DSH METROPOLITAN SNF BLDG REPAIR PROJECT

Additional Detailed Instructions

ADI Number: 01.1

Punch Report

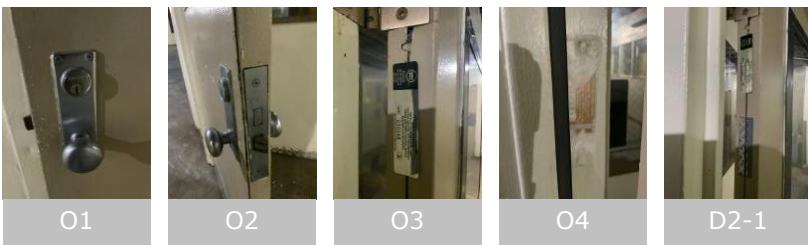
D2: Door damaged (bent, dented, delaminating)

Comments: Door split

Corrective Action: Replace

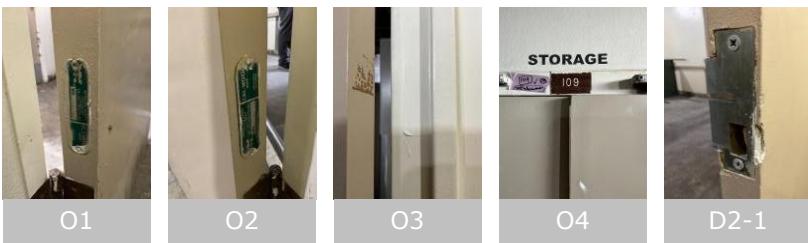
Comments: Damage on inactive door. See photos.

Corrective Action: Replace

**Building:** SNF**Non-Compliant****Level:** 419**Mark:** 419-142

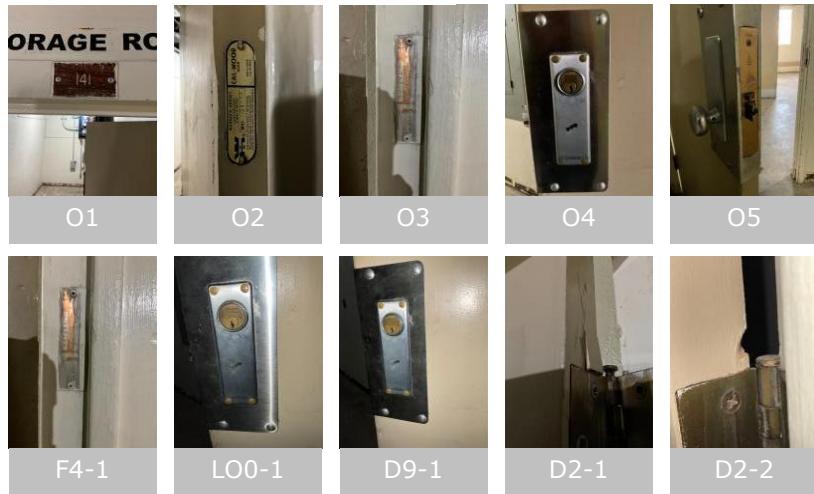
Comments: Exterior knob is missing

Corrective Action: Replace

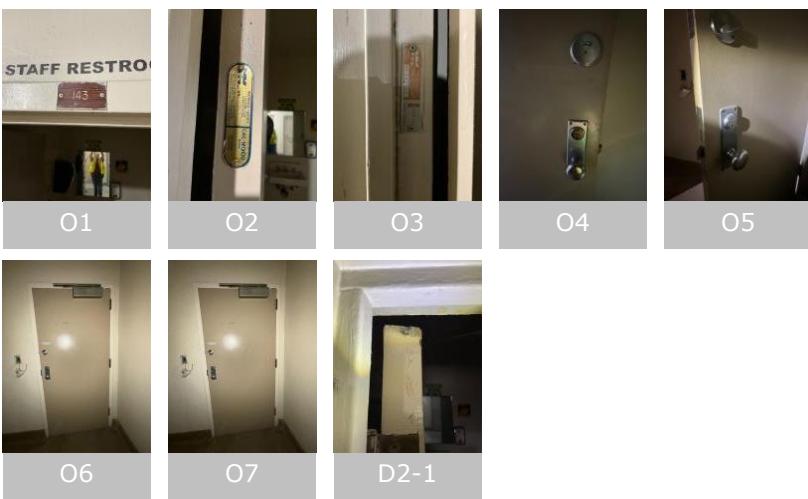
D2: Door damaged (bent, dented, delaminating)

Comments: Rounding at top hinge side

Corrective Action: Replace

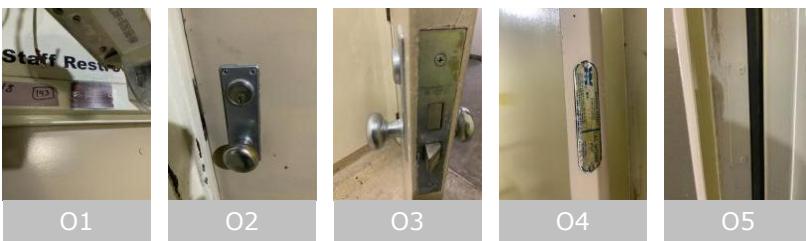
D2: Door damaged (bent, dented, delaminating)

Comments: Door split

Corrective Action: Replace

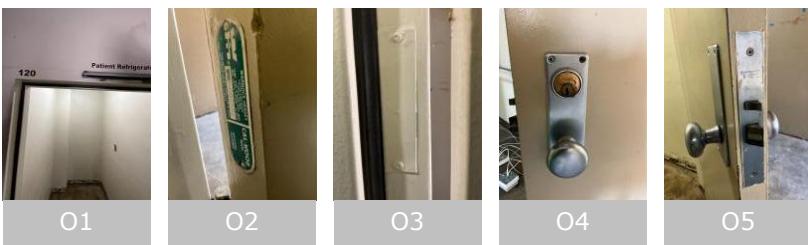
F4: Missing/painted/illegible label

Comments: Painted
